**Submission – DA2025/0132, Review of Amended Plans
Proposed McDonalds, 37 Roseberry Street, Balgowlah**

PEER REVIEW OF THE PROPOSED MCDONALDS (DA2025/132) AT 37 ROSEBERRY STREET, BALGOWLAH

RE: PROPOSED McDONALD'S, 37 ROSEBERRY STREET, BALGOWLAH
FURTHER RESPONSE TO TRAFFIC MATTERS

**Existing weekday afternoon
peak hour traffic flows plus
development traffic**
Figure 1

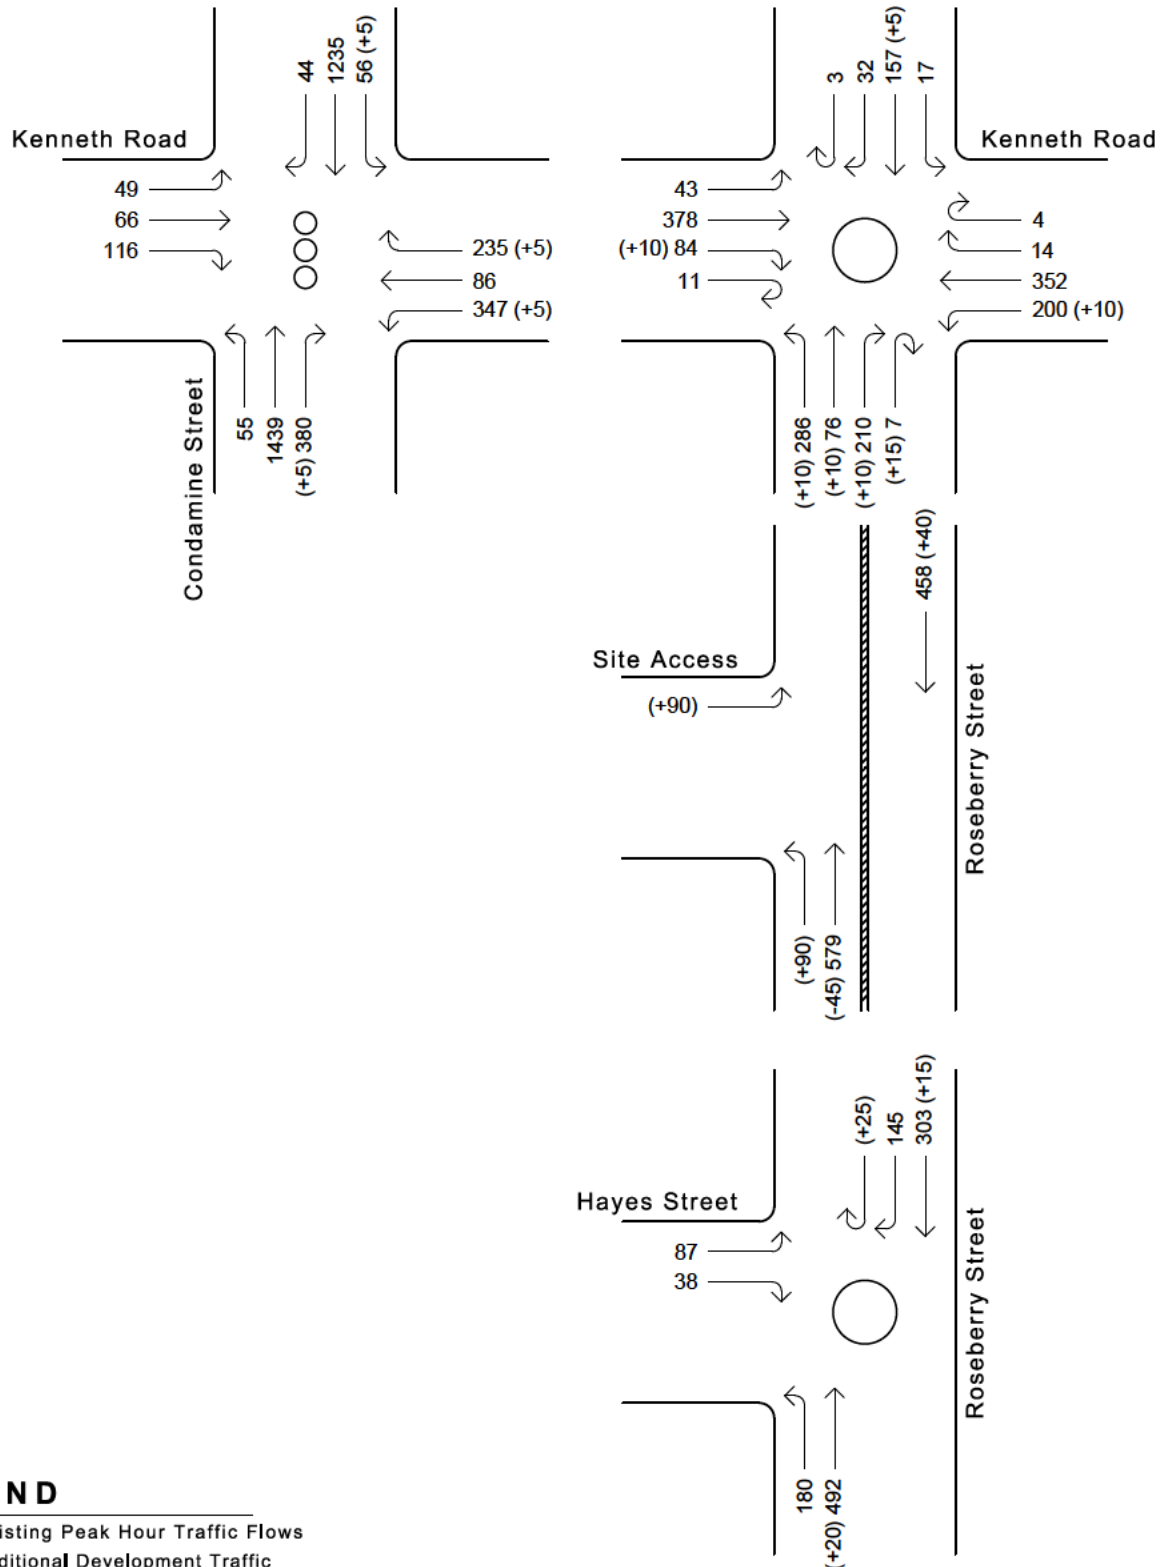
- A. It is acknowledged that as a result of the proposed centreline median, the traffic assignment of the inbound and outbound vehicles is changed, as vehicles can no longer make a right turn into or out of the site.
- B. Figure 1 and Figure 2 of the **CBRK Letter** details the addition of ‘external trips’ to the existing traffic volume diagram. However, the distribution of these external trips does not appear to consider the ‘passing trade’ traffic from Condamine Street or the surrounding residential street. The Figures indicate that there are a total of 140 vehicle trips (70 inbound, 70 outbound) during the Weekday PM Peak hour and 180 vehicle trips during the Saturday Midday peak hour from the proposed site access.

- H. Based on the interpretation of the **CBRK Letter**, it appears that the passing trade traffic has not been distributed appropriately to/from the proposed McDonalds, resulting in a 50% underestimation in the turning volumes at the signals. Vehicles exiting the site are not simply merging back onto the arterial road, as the proposed development does not have vehicular access via Condamine Street.

7. The traffic distribution has been revised as a result of access to the site being limited to left in/left out on Roseberry Street as shown in Figures 1 and 2. Some 55% of traffic would arrive from the north and some 45% from the south. 50% passing trade has been applied to traffic turning left into the site from Roseberry Street. Figures 1 and 2 show the following increases in traffic on the adjacent road network in the weekday afternoon and Saturday midday peak hours:

PROPOSED 410mm WIDE MEDIAN, REFER TO DETAIL BELOW.

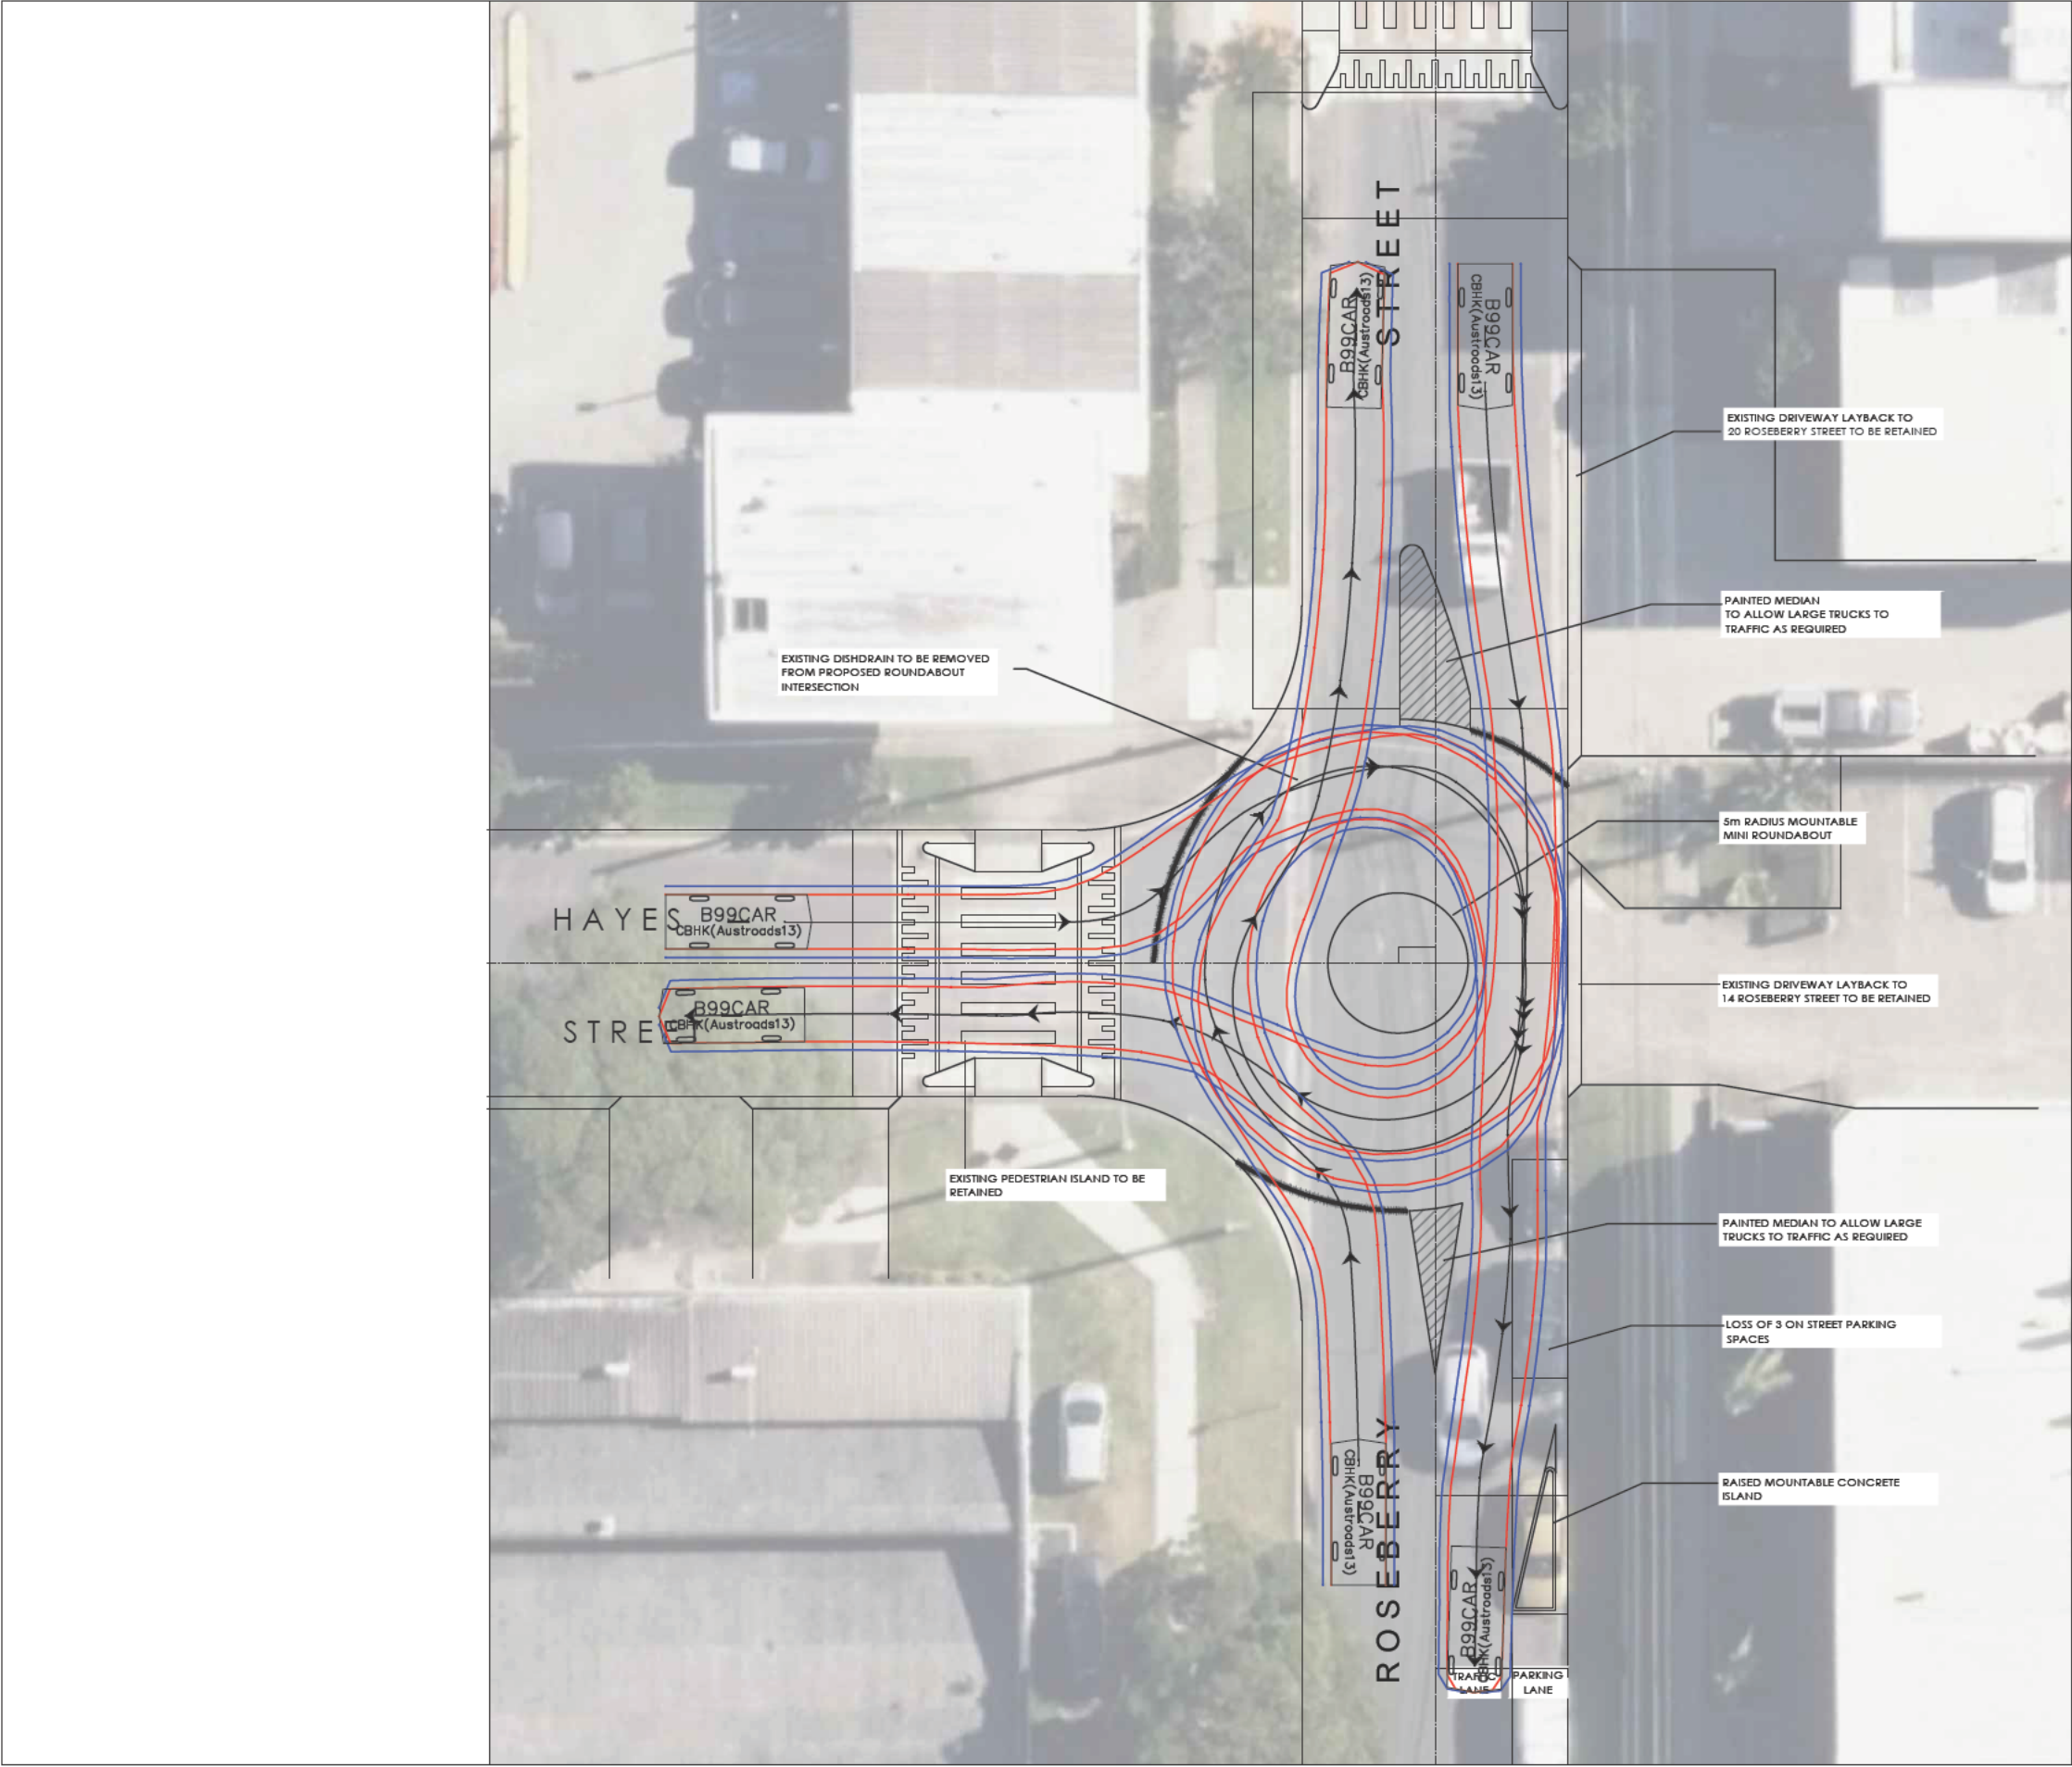
- A. The proposed centreline median is approximately 410mm in width. It is acknowledged that within Council’s RFI, a median width between 300-500mm was recommended, however, under *AUSTROADS Guide to Road Design Part 3*, the minimum width for any raised median is 500mm, which the centreline median does not achieve. Widening the median to 500mm would result in travel lanes lesser than 3.0m wide or potentially reduce the width of the verge if any kerb setback adjustment were to occur.

17. A concept sketch of a 410 mm wide median some 27 metres along the Roseberry Street frontage is shown in Entec Consultants Sketch SK002 REV and is provided in Attachment A. This shows that it appears feasible to provide a median opposite the site access to limit access to left in/left out and maintain one traffic lane in each direction and kerbside parking on the eastern side of Roseberry Street. The median does not impact access to other properties and starts some 10 metres south of the painted splitter island on the southern approach of the Kenneth Road roundabout, so as to not impact large trucks turning at the roundabout.

B99 VEHICLE SWEPT PATHS

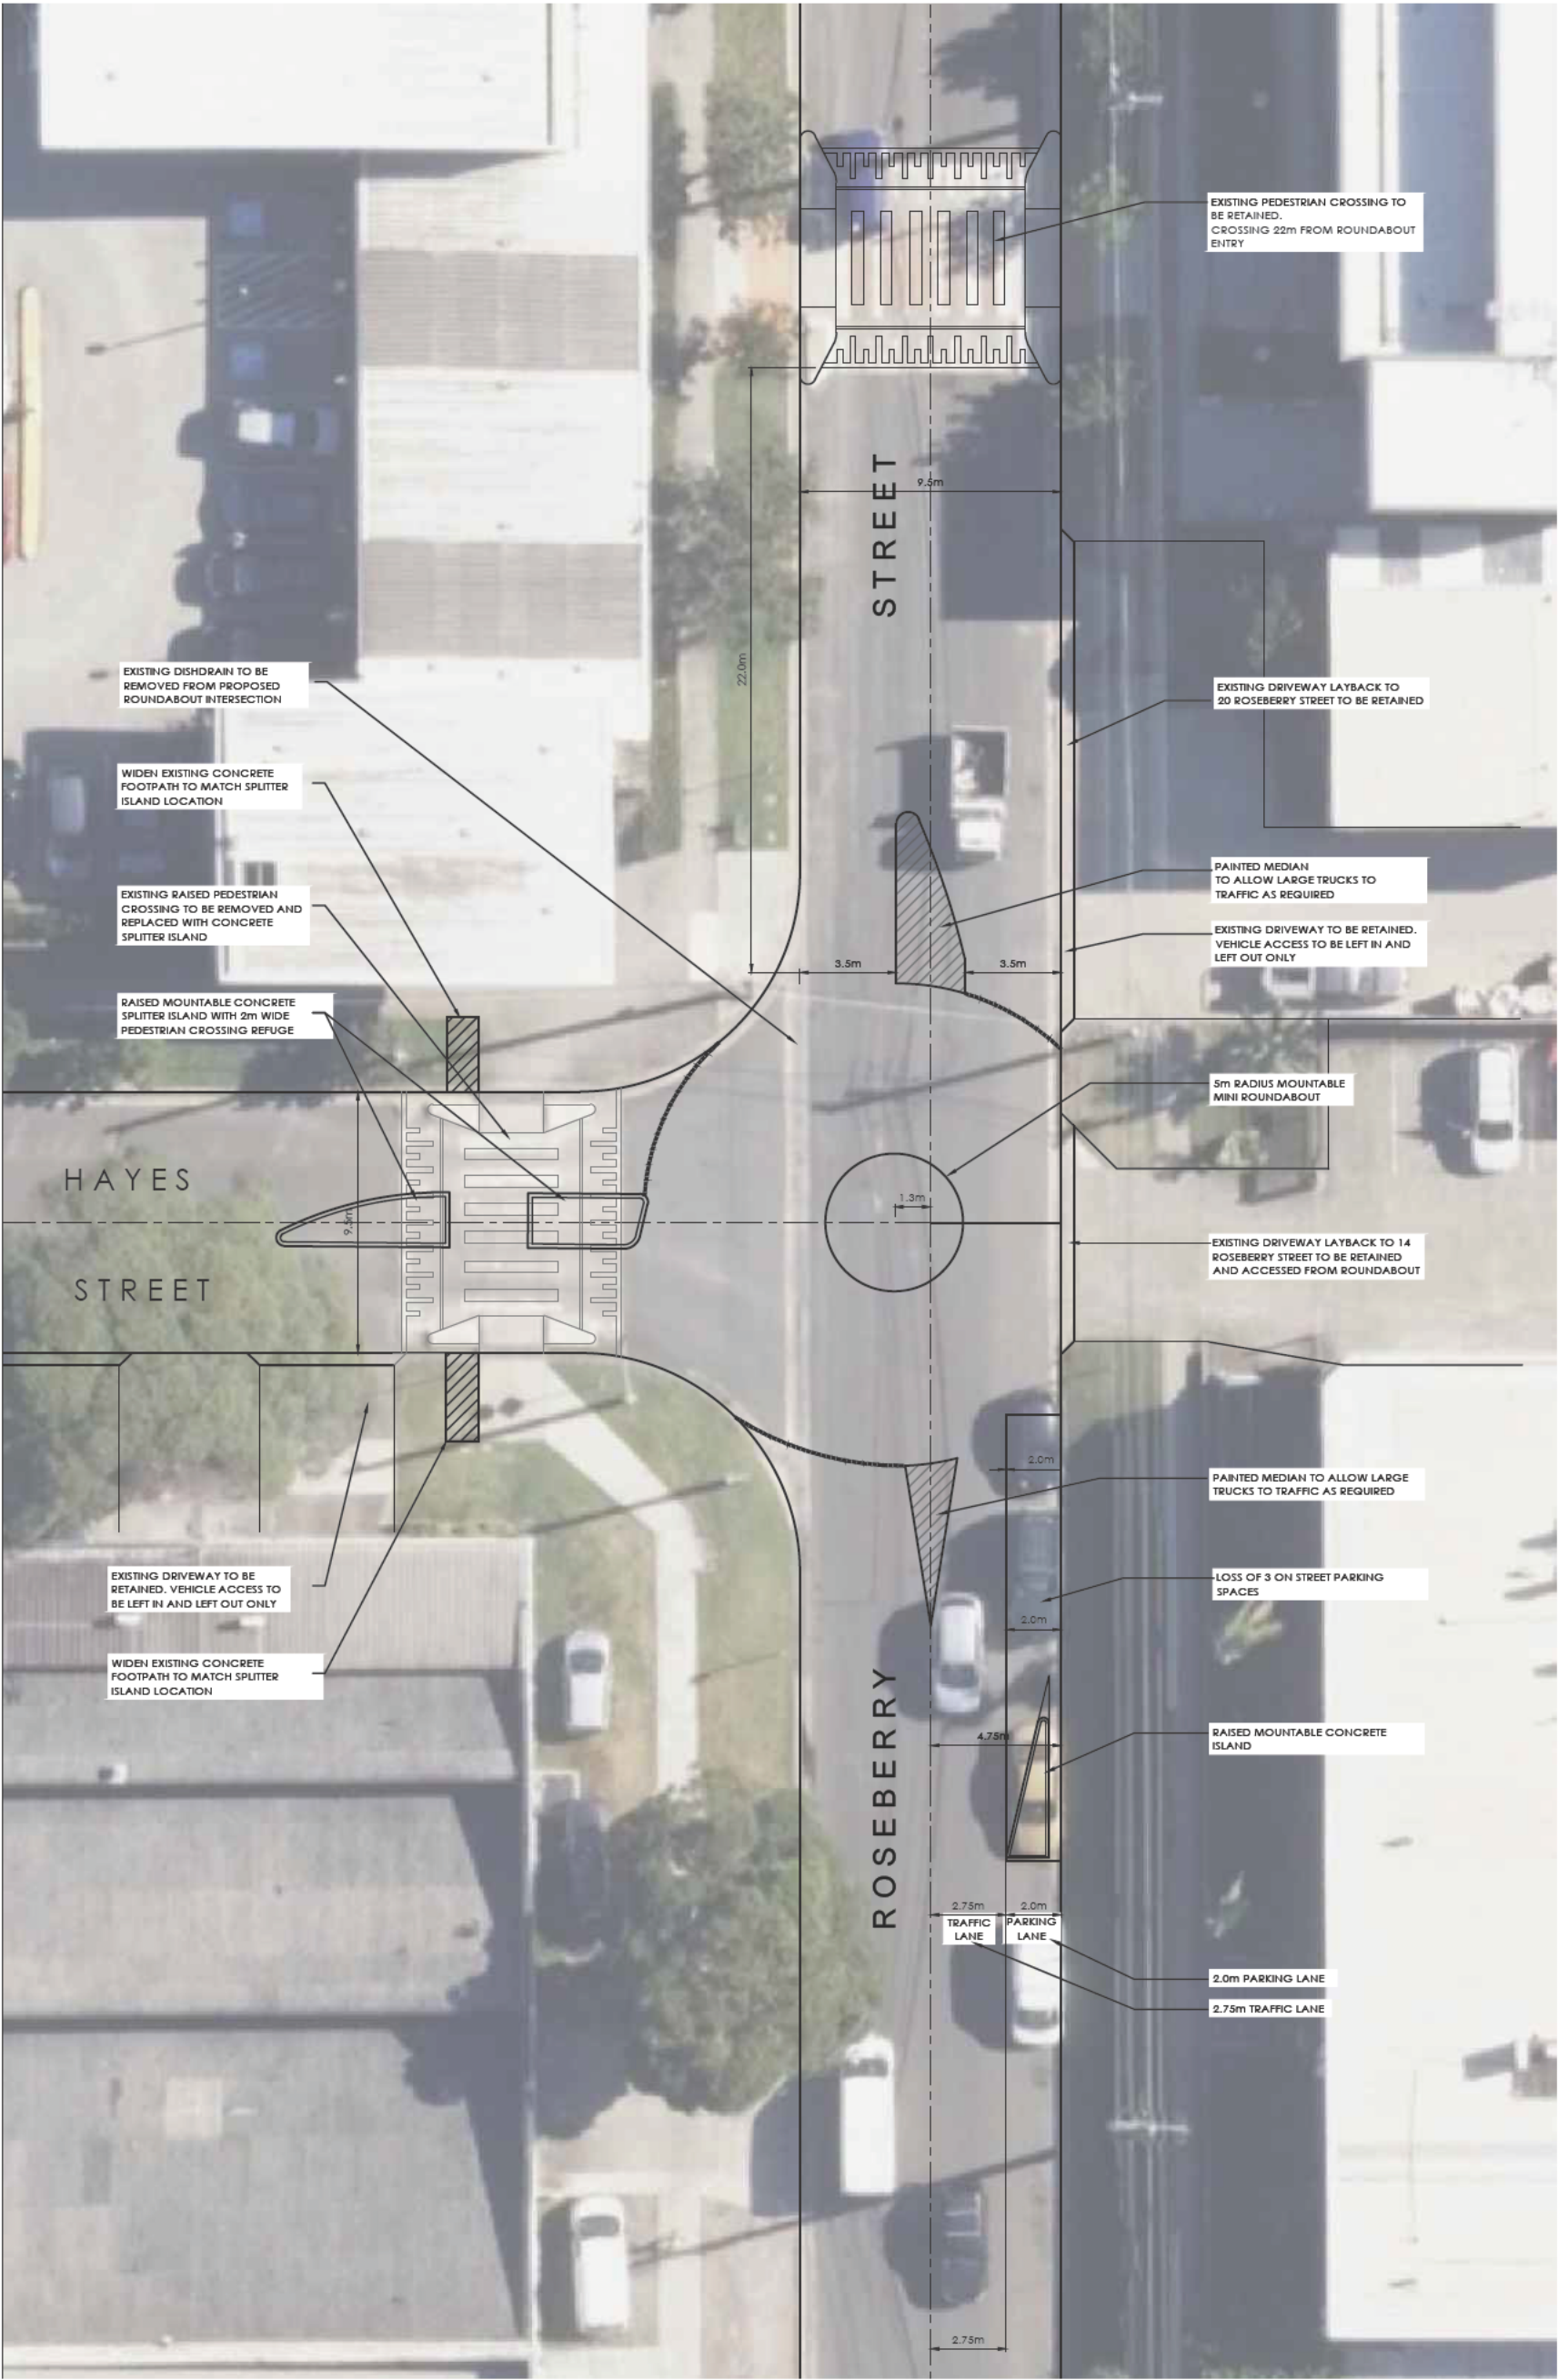
- M. It is recommended that swept paths are undertaken of the proposed service vehicle and Council's waste collection vehicle to determine if the roundabout requires the restriction of use from larger vehicles.

- N. It is recommended that swept paths are undertaken of the proposed roundabout utilising the recommended checking vehicle under *AUSTROADS Design Vehicle and Turning Path Templates Guide*.

- A. It is acknowledged that the **CBRK Letter** provides a swept path assessment of the roundabout concept utilising a B99 vehicle.
- B. A swept path assessment should be undertaken of the roundabout utilising Northern Beaches Council's waste vehicle as a minimum. Questions arise to the proposed approach and departure routes of service vehicles associated with the proposed McDonalds.
